# CHANGE ORDER

Project Name: **Haverhill Consentino Middle School** CO No. **17**

Architect's Project No. **21-0818**

Subject: **Community Room PR-72** PCO Issue Date: **2025.11.12**  
 PCO Reviewed: **2025.11.14**

**JD-123**

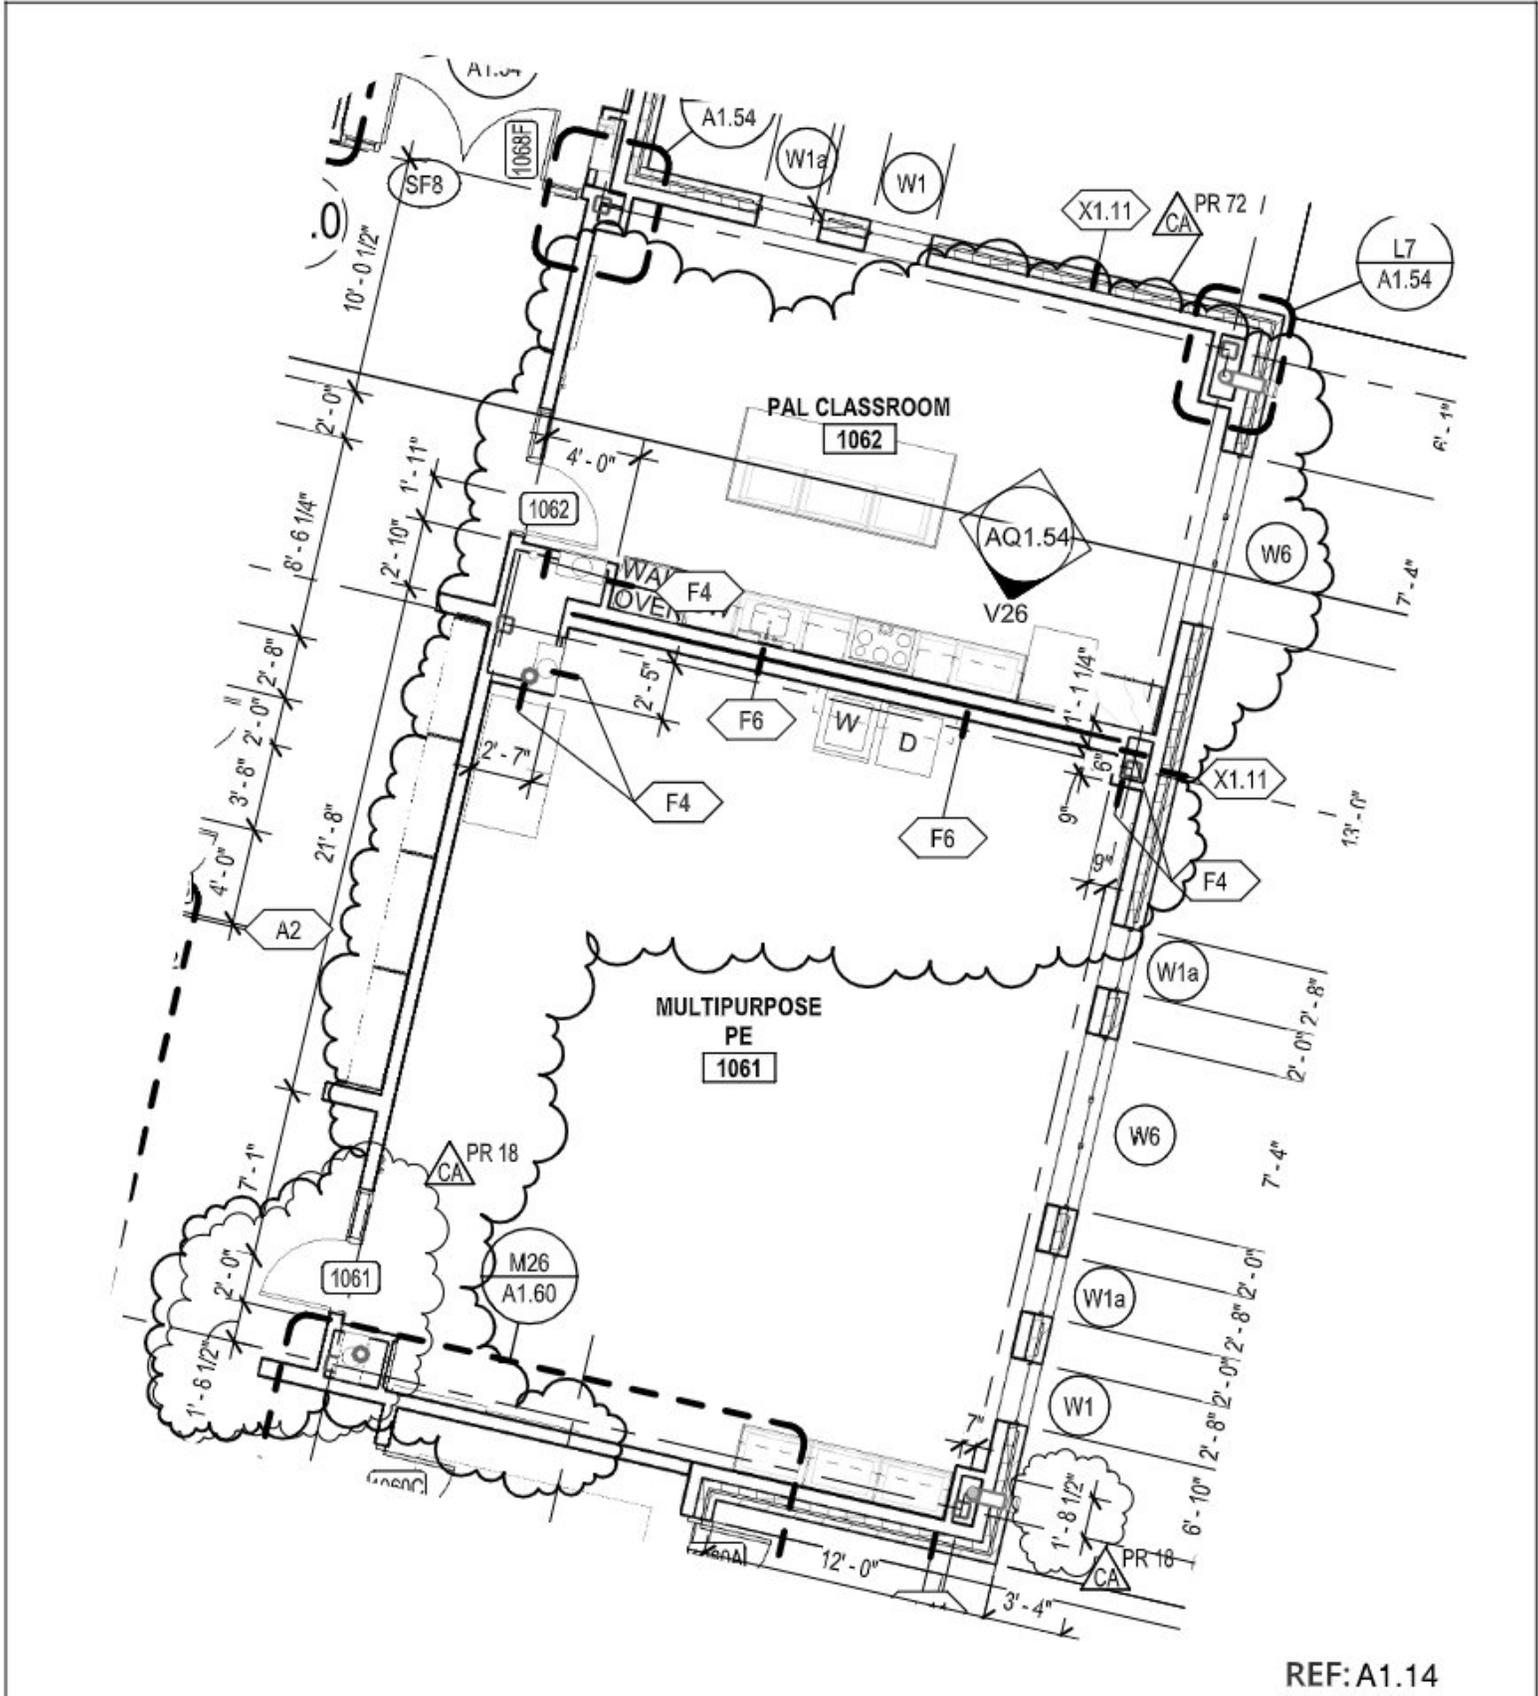
Sheet S2.02, SECTIONS, add new detail 9, as shown on attached sketch **JD-123**.

JD-124

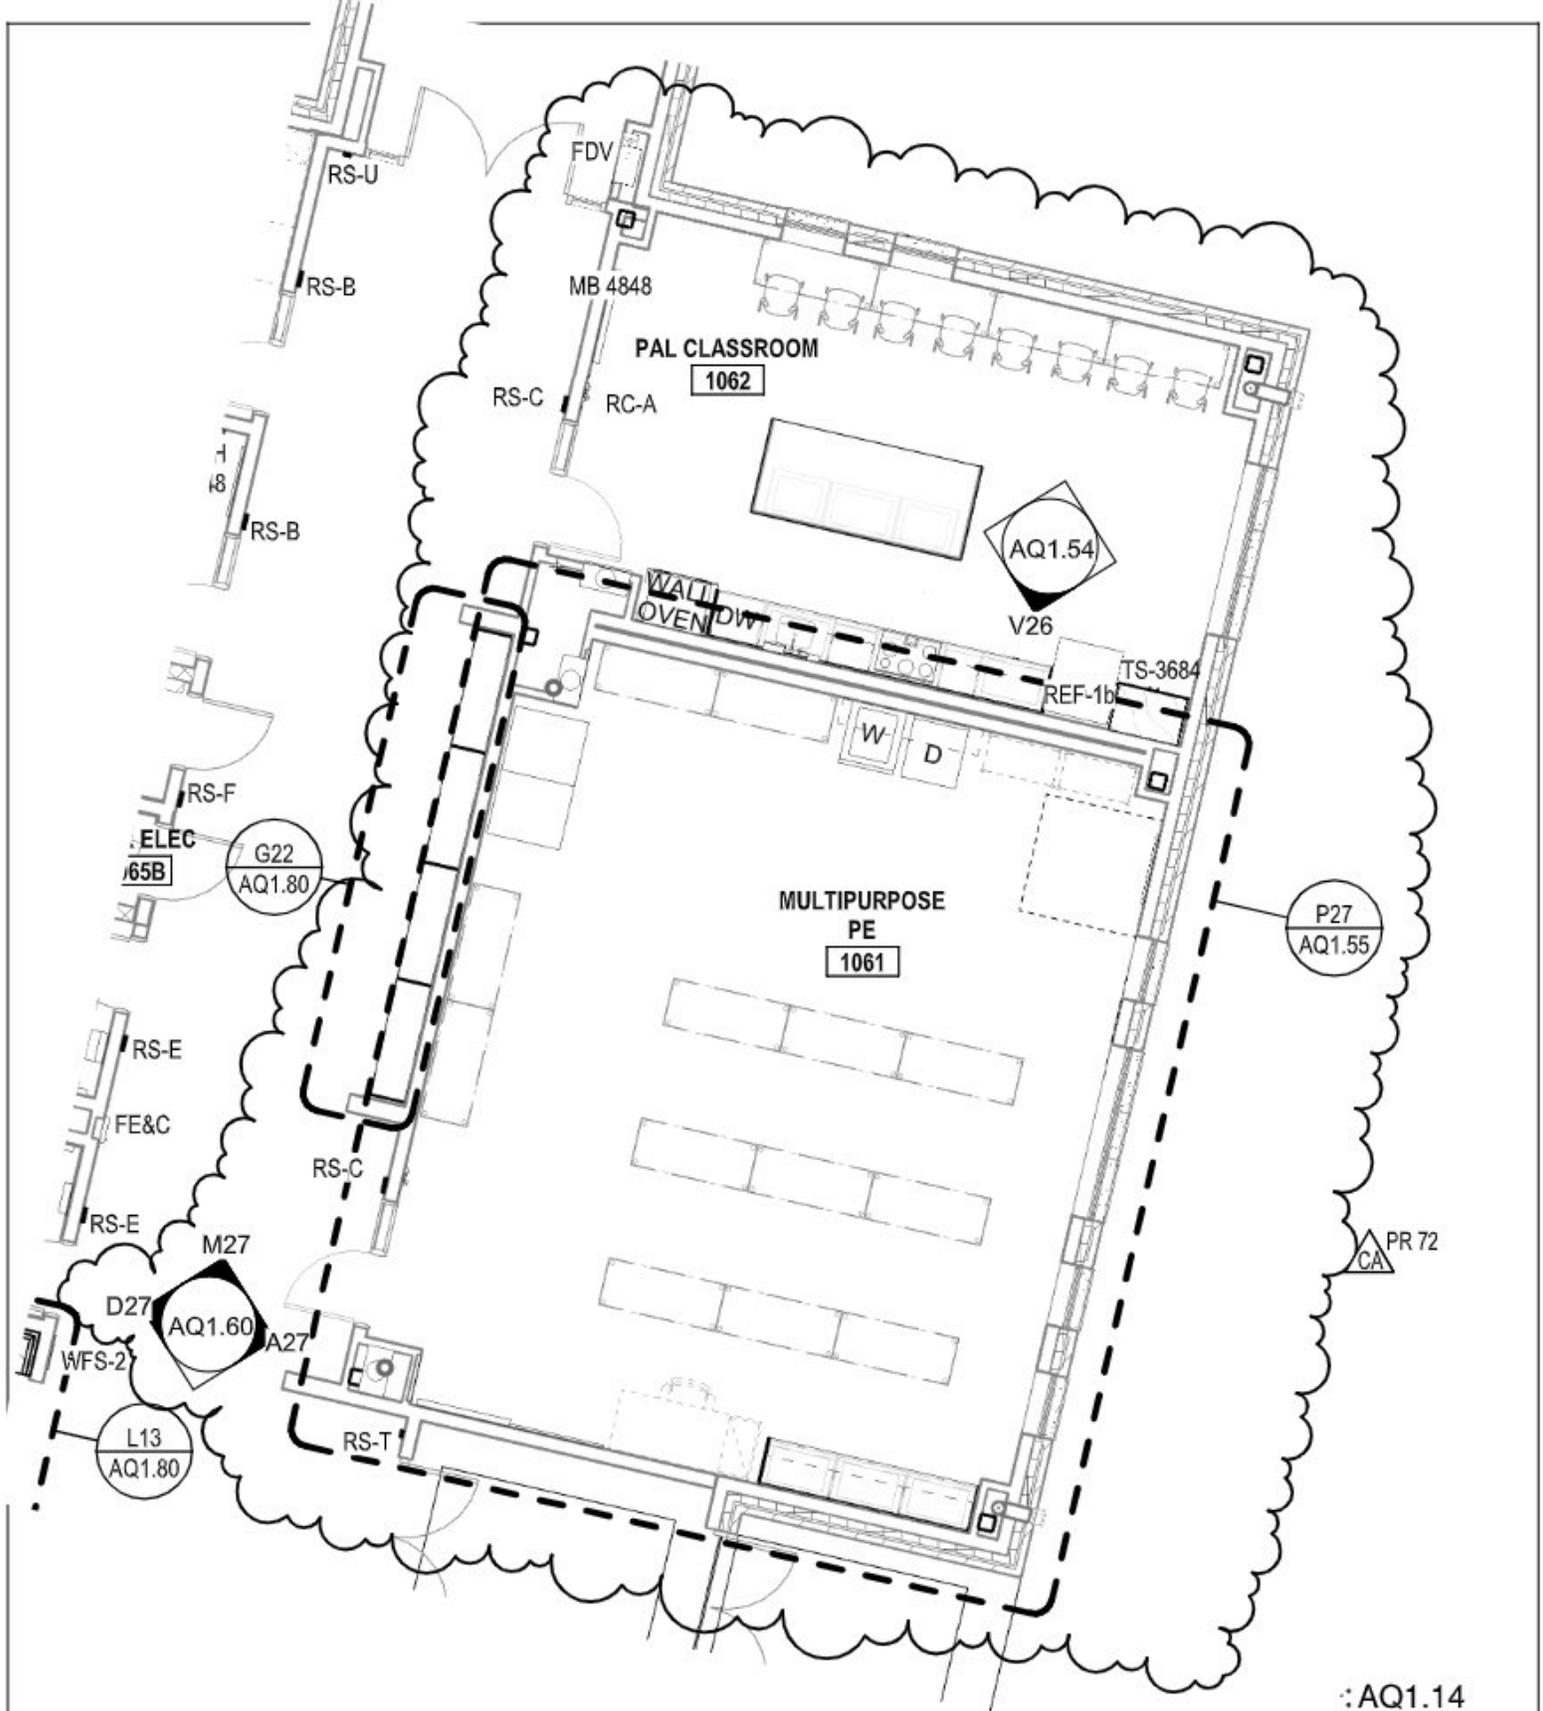
Sheet A1.14, LEVEL 1 – AREA D, revise plan at PAL Classroom 1062 and Multipurpose PE 1061 as shown on attached sketch **JD-124**.

JD-125

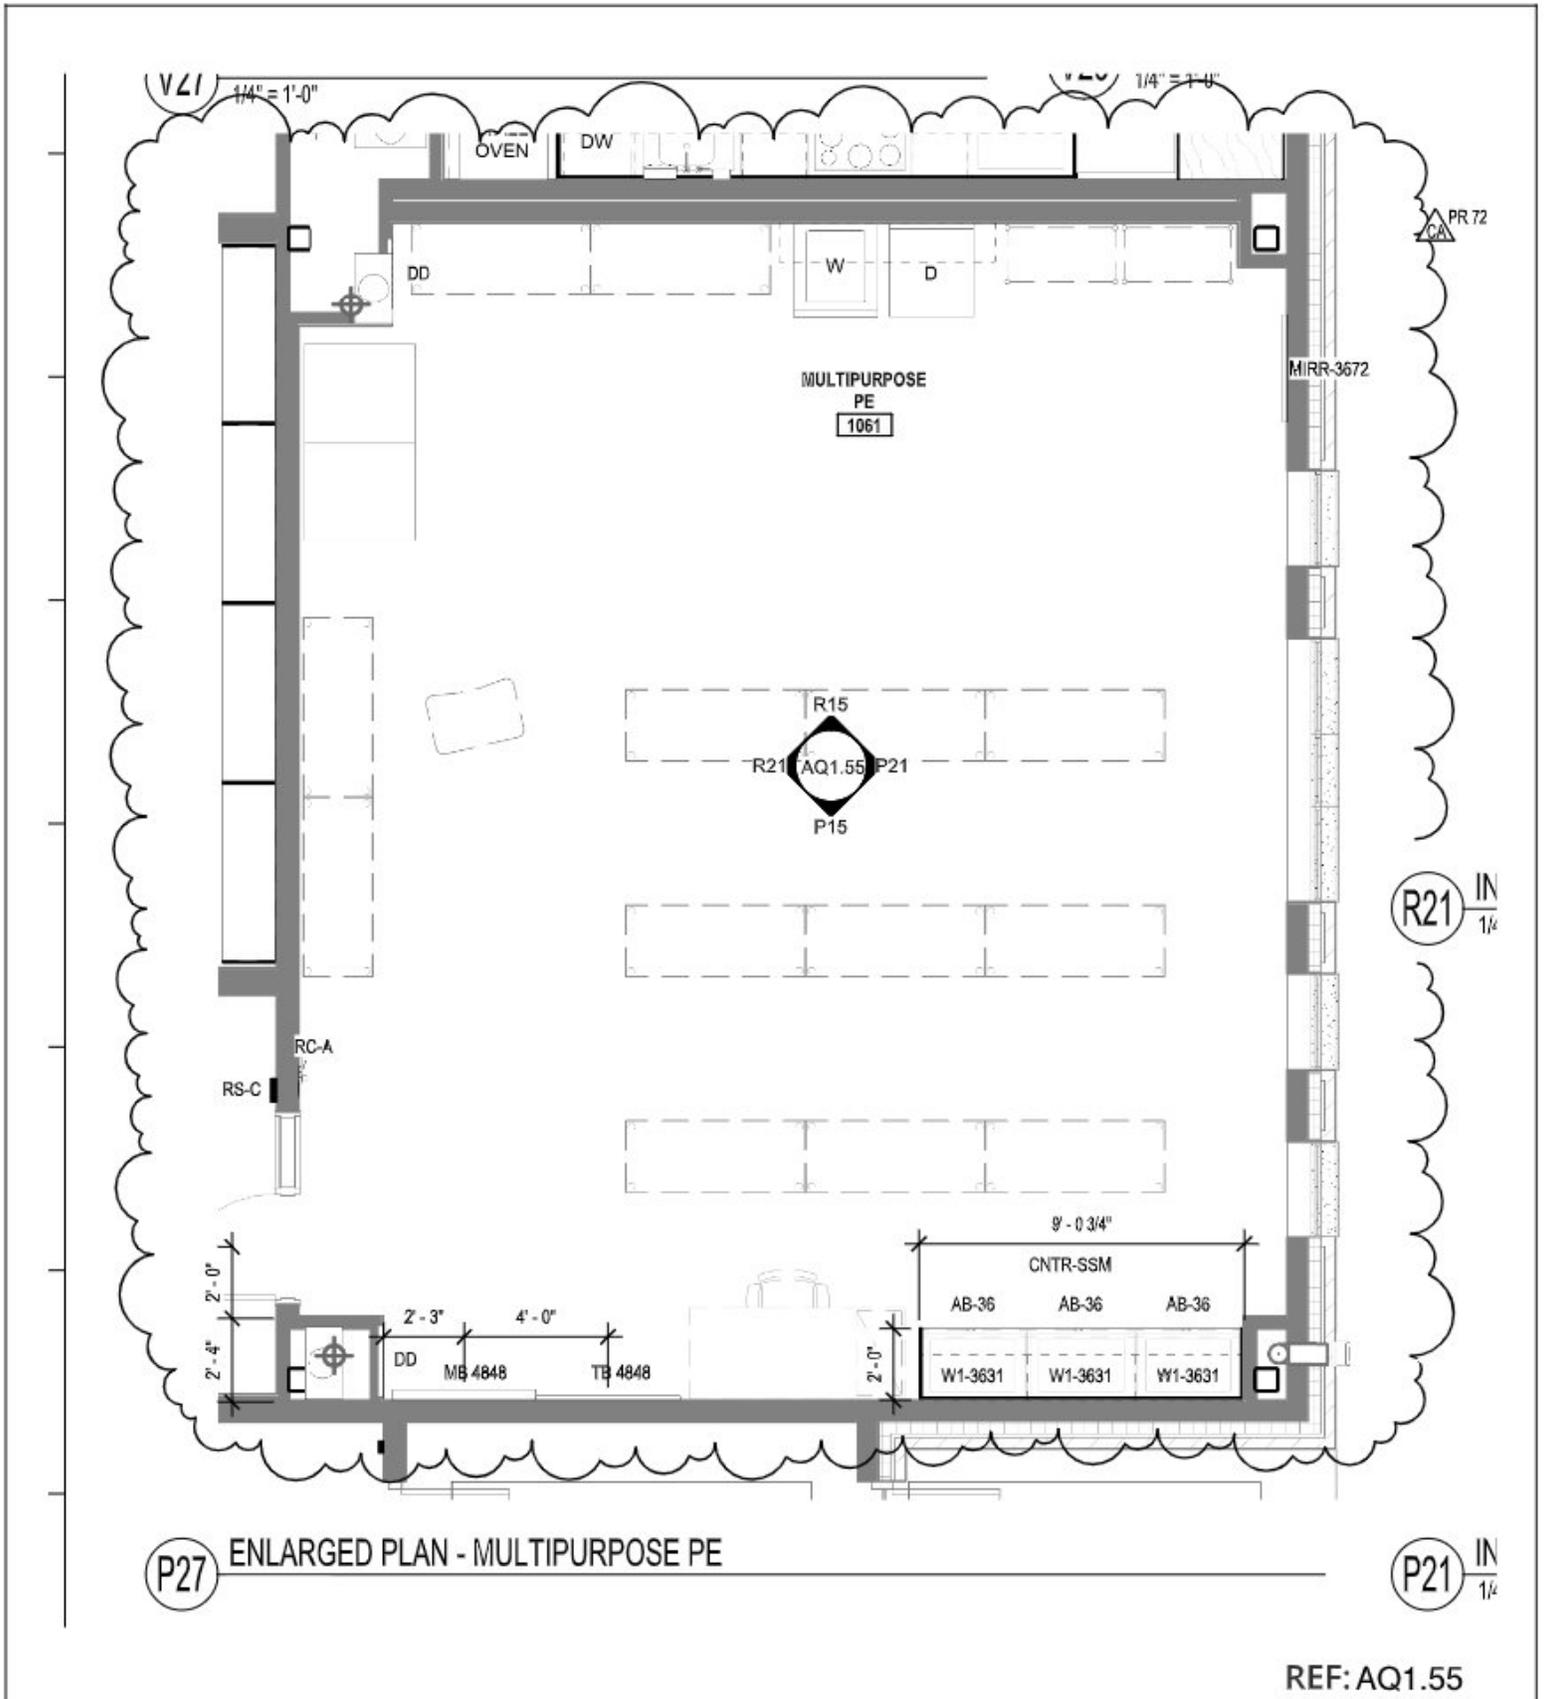
Sheet AQ1.14, LEVEL 1 EQUIPMENT PLANS – AREA D, revise plan at PAL Classroom 1062 and Multipurpose PE 1061 as shown on attached sketch **JD-125**.

JD-127

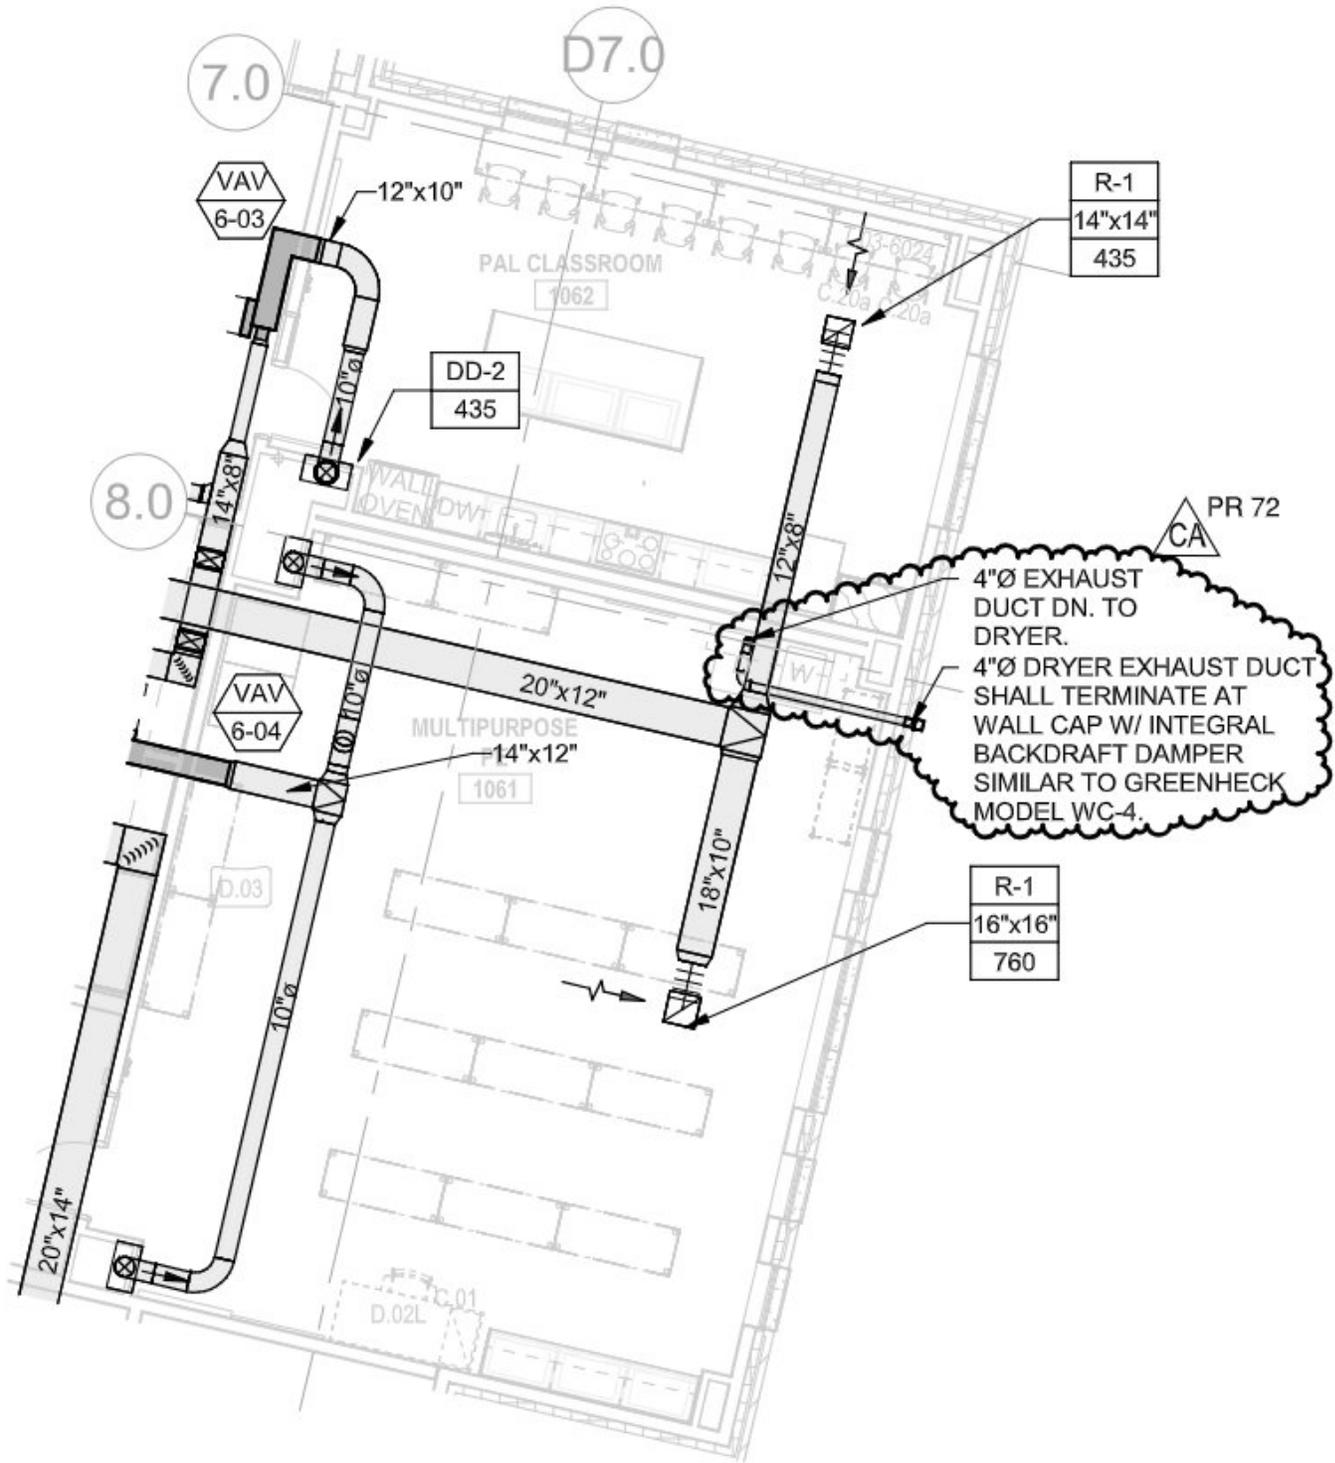
Sheet AQ1.54, CASEWORK PLANS AND ELEVATIONS, add new elevation V26, CASEWORK ELEVATION – PALS as shown on attached **JD-127**.
